**Falcon Place (SUB 12-01)  
Submission for Completeness**

3J Consulting acts on behalf of OLC 14, LLC. and JT Smith Companies in preparing this letter to address the incompleteness notification released by your office on December 13, 2012 relating to the Falcon Place Subdivision. This letter has been prepared to both address each of the items listed within the City's incompleteness determination and to describe the changes which have occurred to the preliminary plans and submission materials.

**Project Name: Falcon Place (SUB 12-01)**  
**Project No: 12093**  
**RE: Stormwater Management Memorandum**

SHEET TITLE  
**TREE PLAN**  
 SHEET NUMBER  
**C1.2**

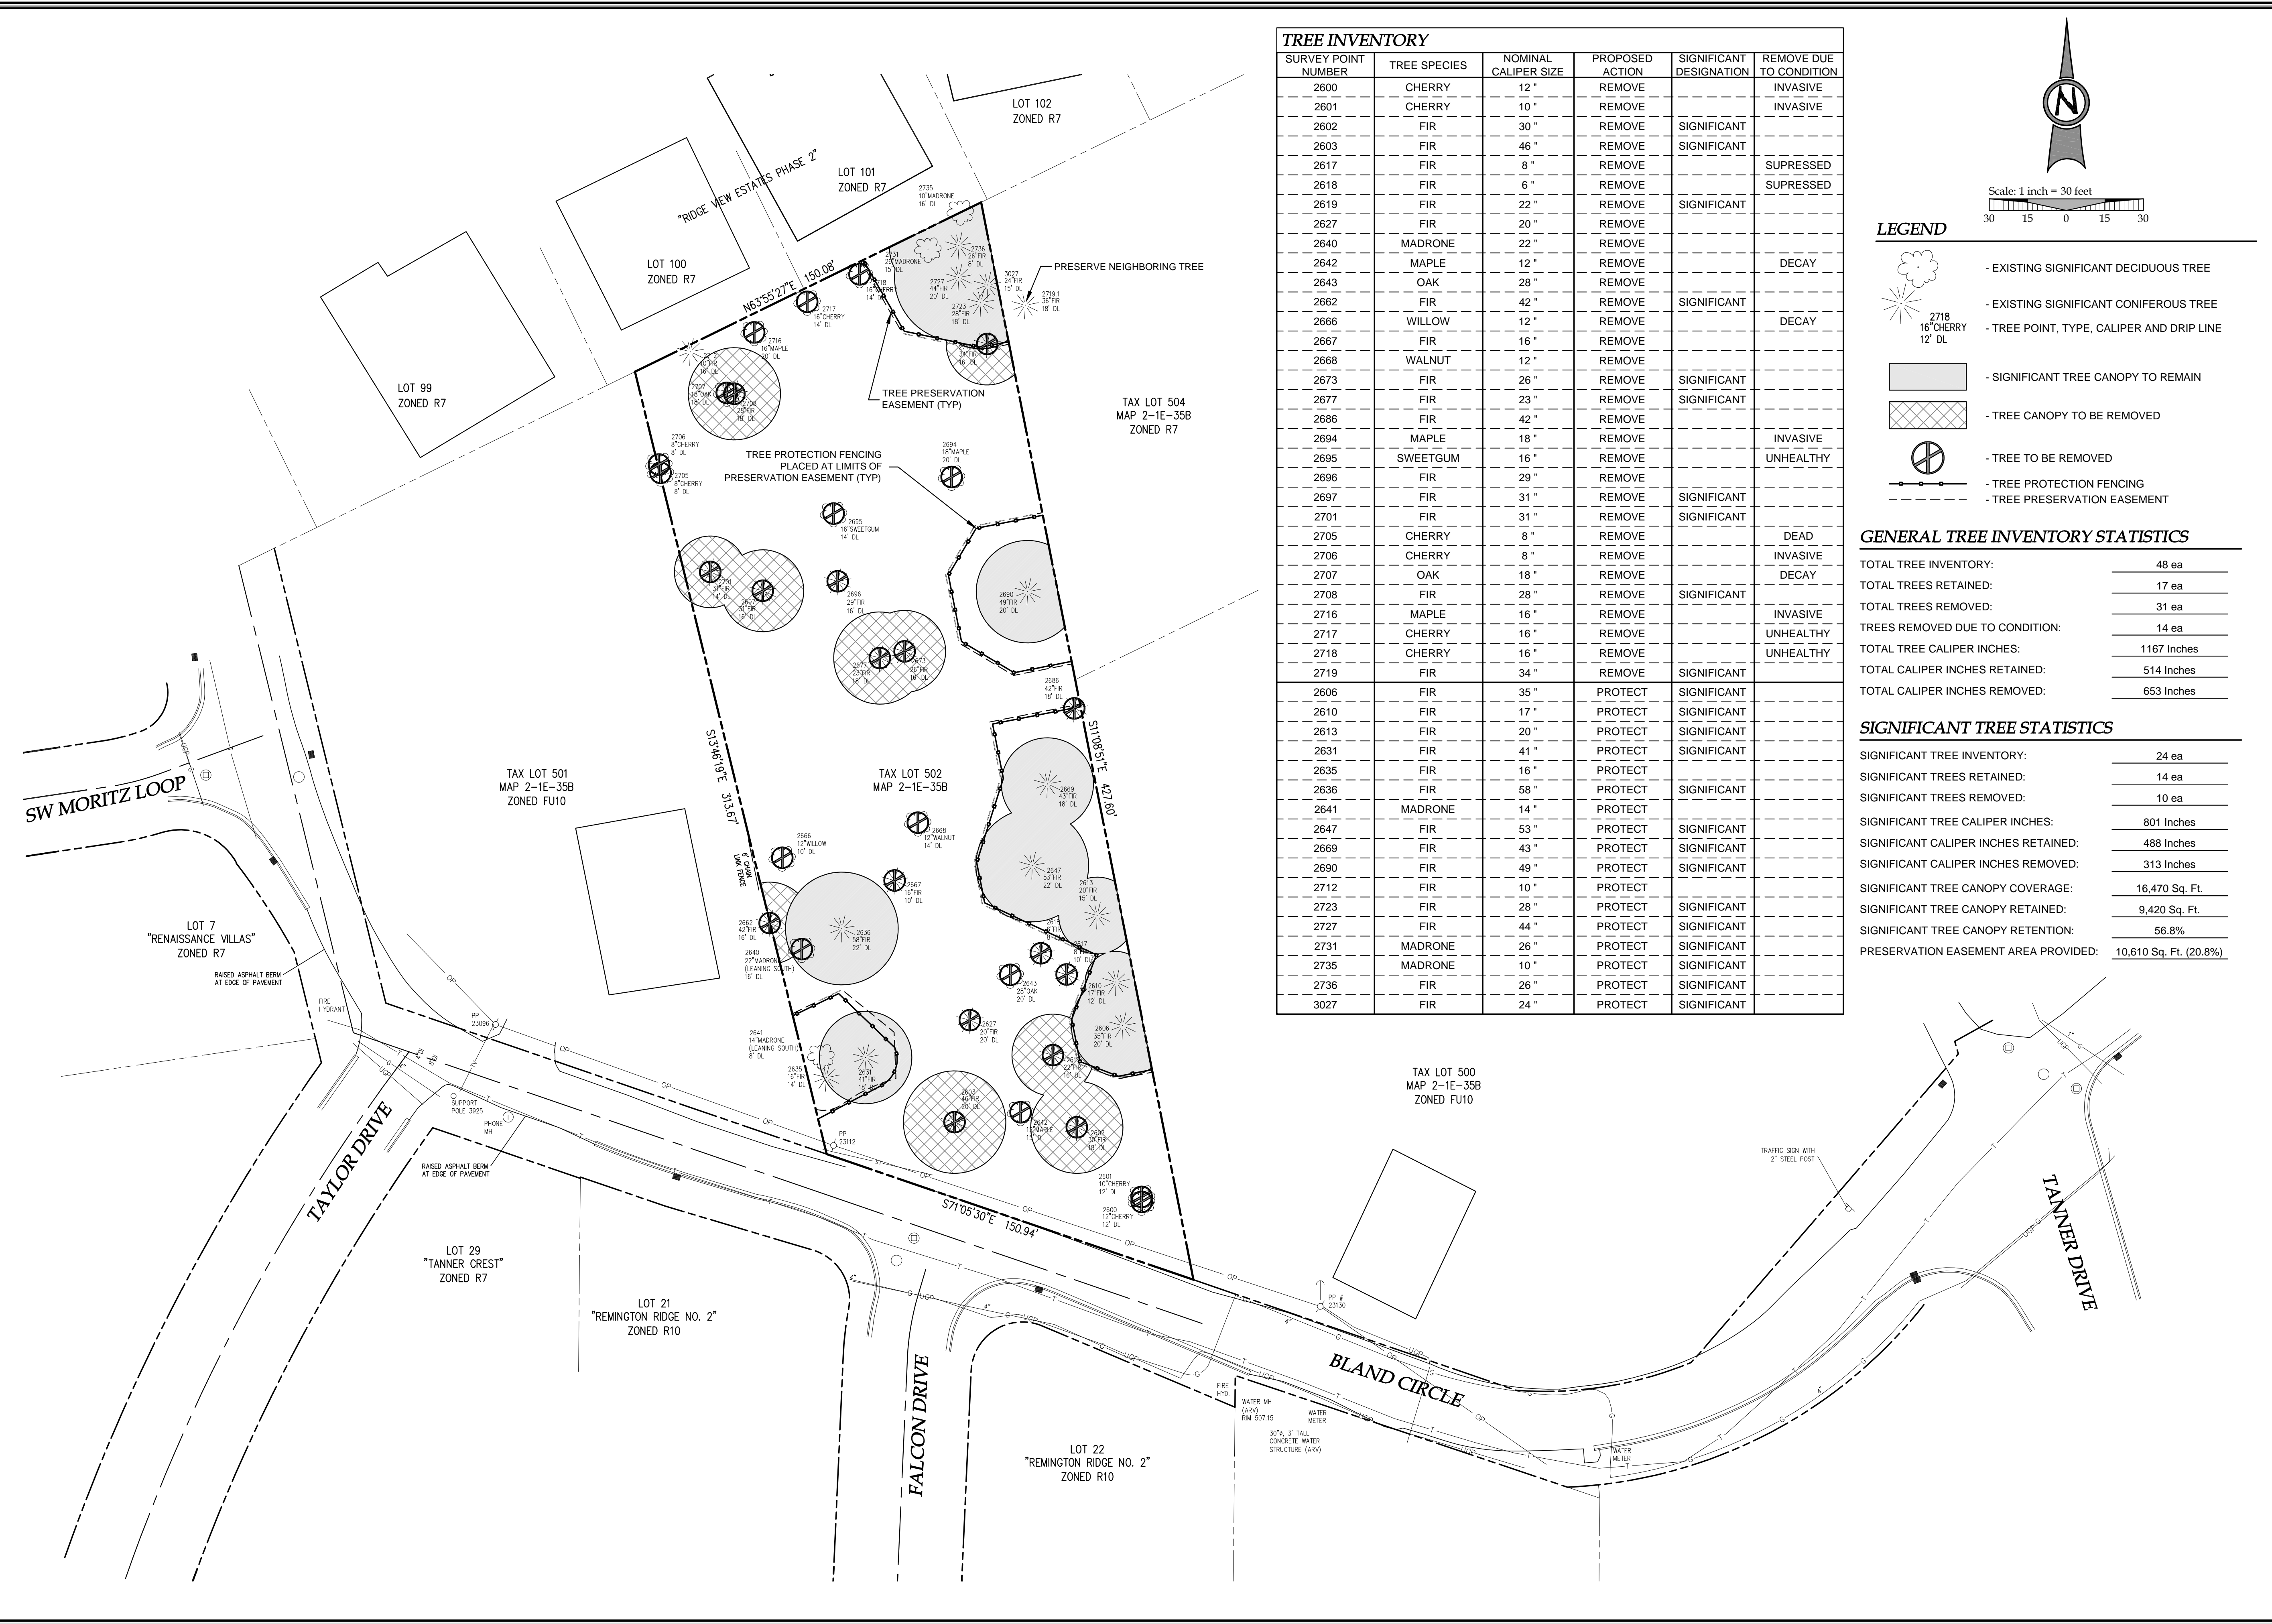
85.160(E)(5)	The applicant need to modify Sheet C.1.2 to show the official map of significant trees	At the time of initial submittal, the official list of significant trees was not available. Sheet C.1.2 has been revised to reflect the current significant tree designations.

SHEET TITLE  
**SLOPE ANALYSIS**  
SHEET NUMBER  
**C1.3**

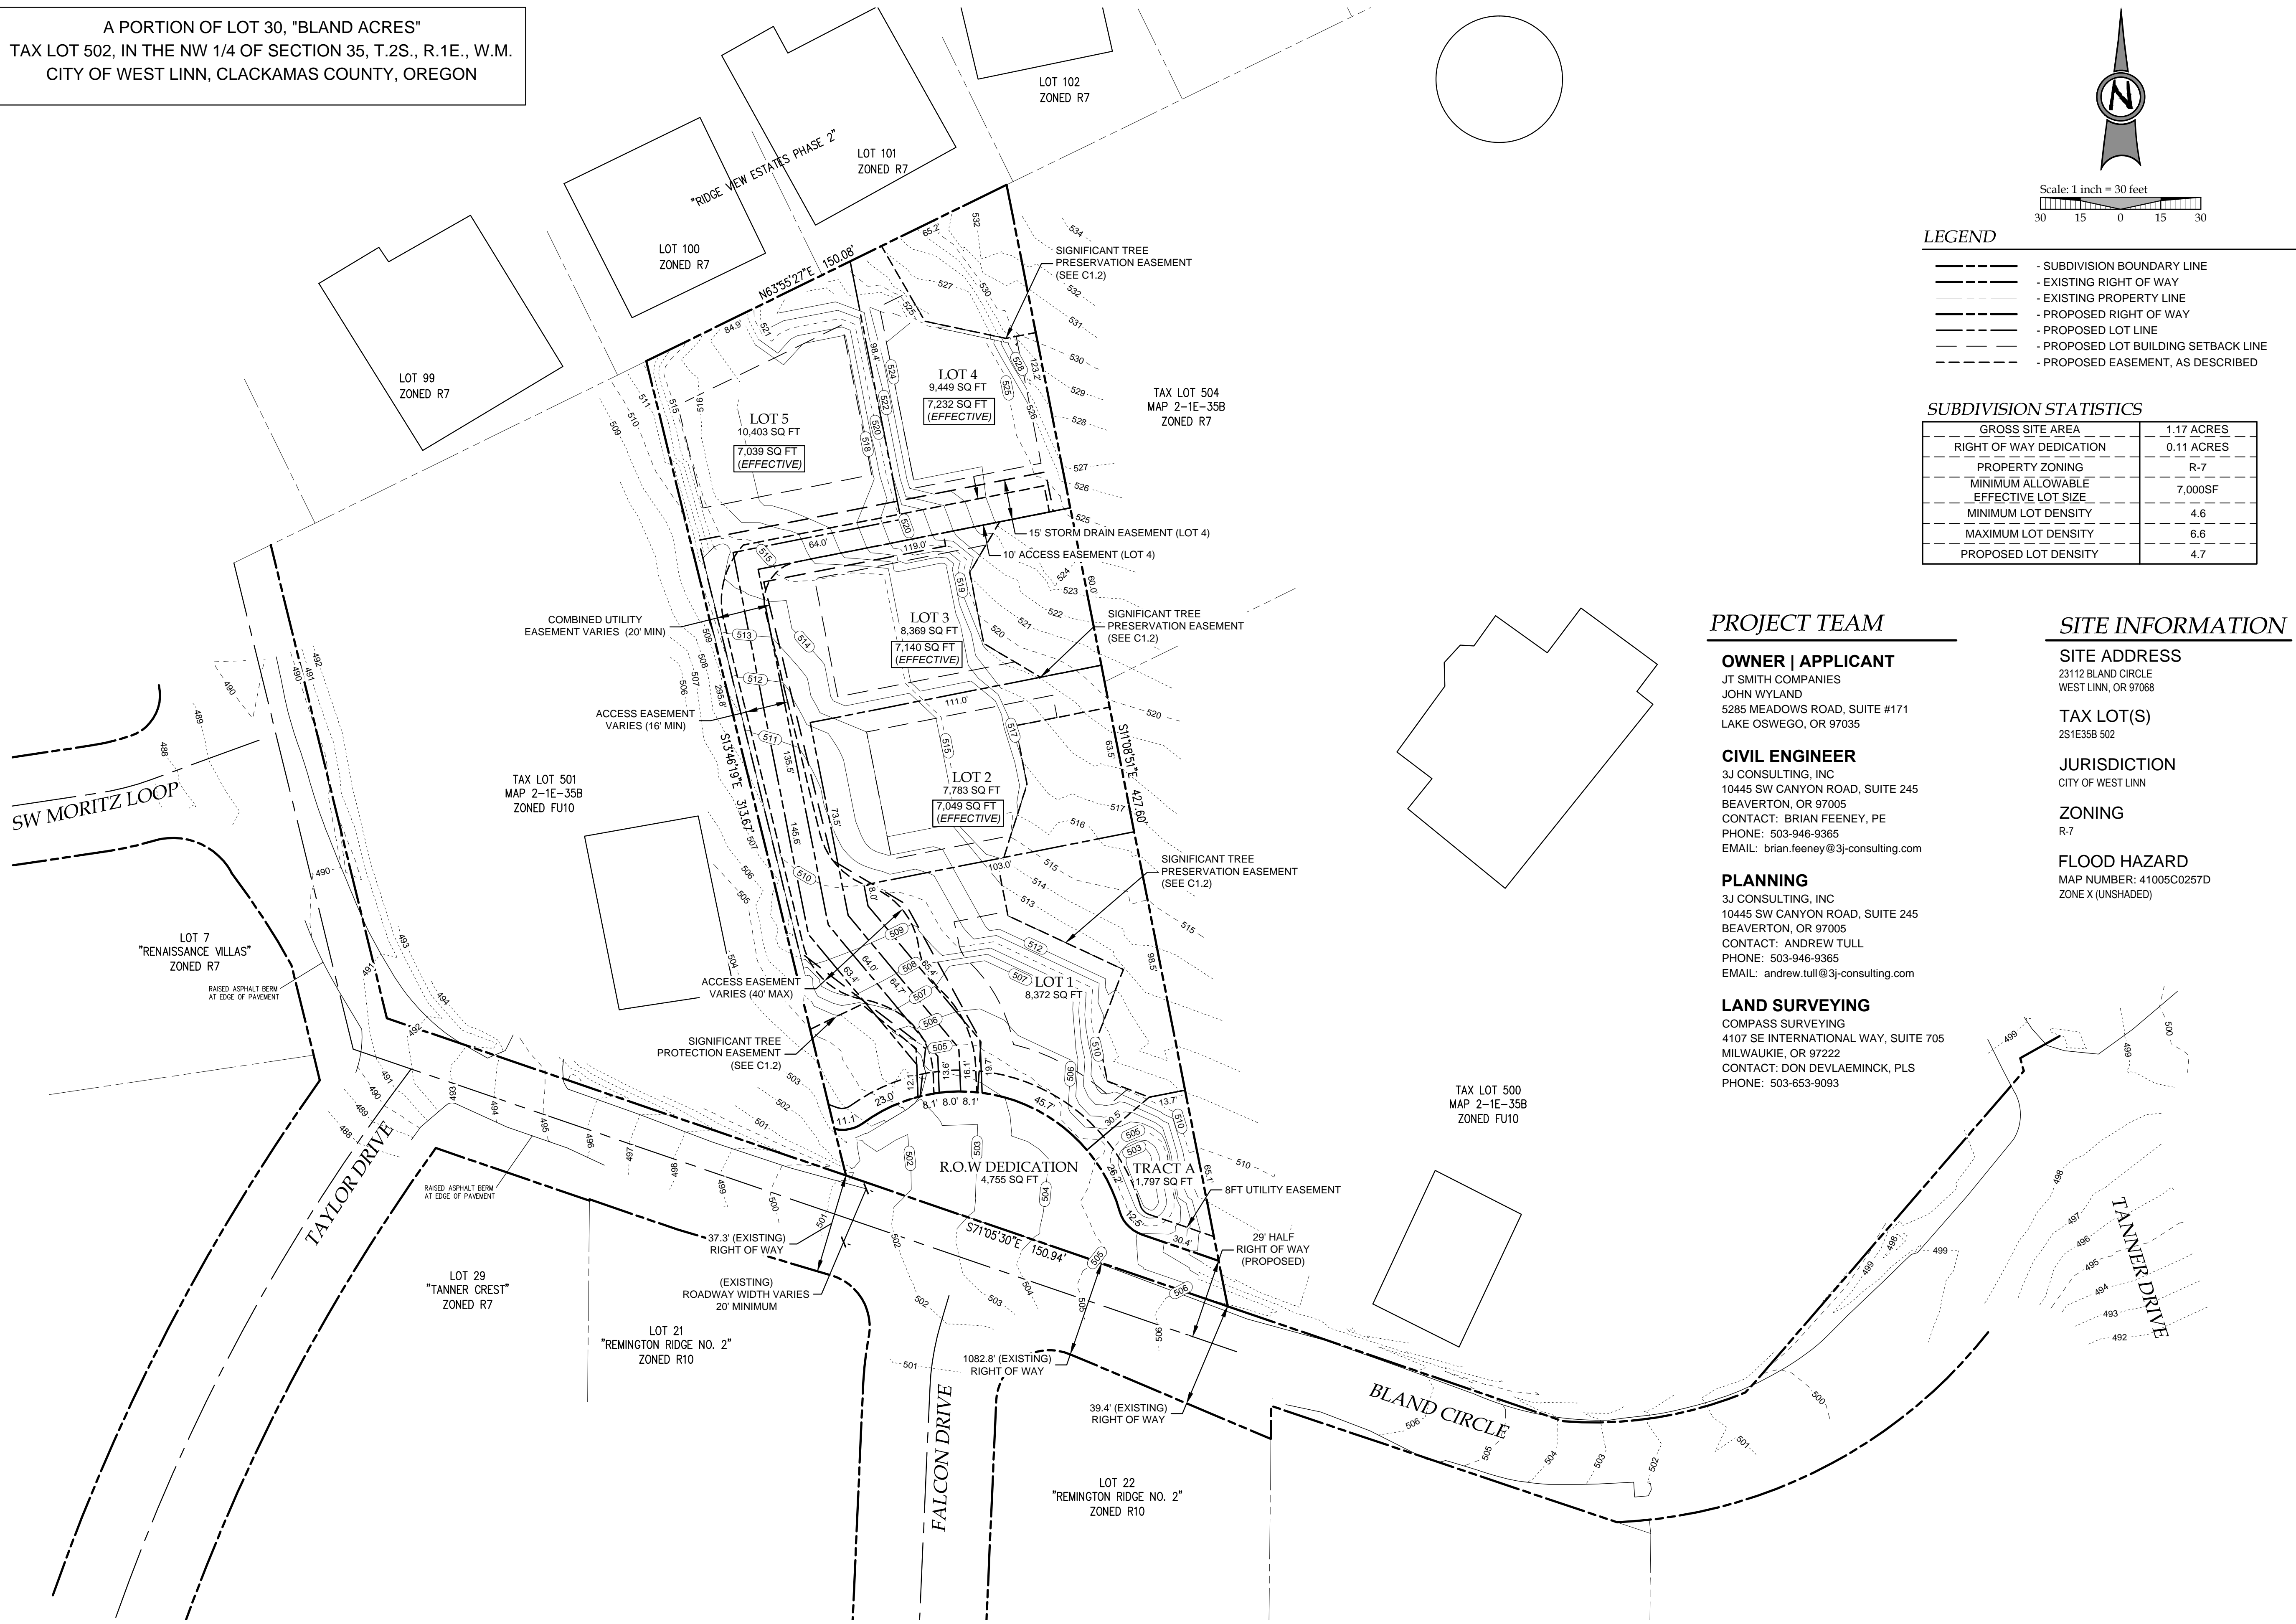
85.170(A)(8)	Need map and table with slope breakdowns per 55.110(B)(3)	A map and table showing the slope analysis has been provided, per 55.110(B)(3) (See Sheet C1.3)
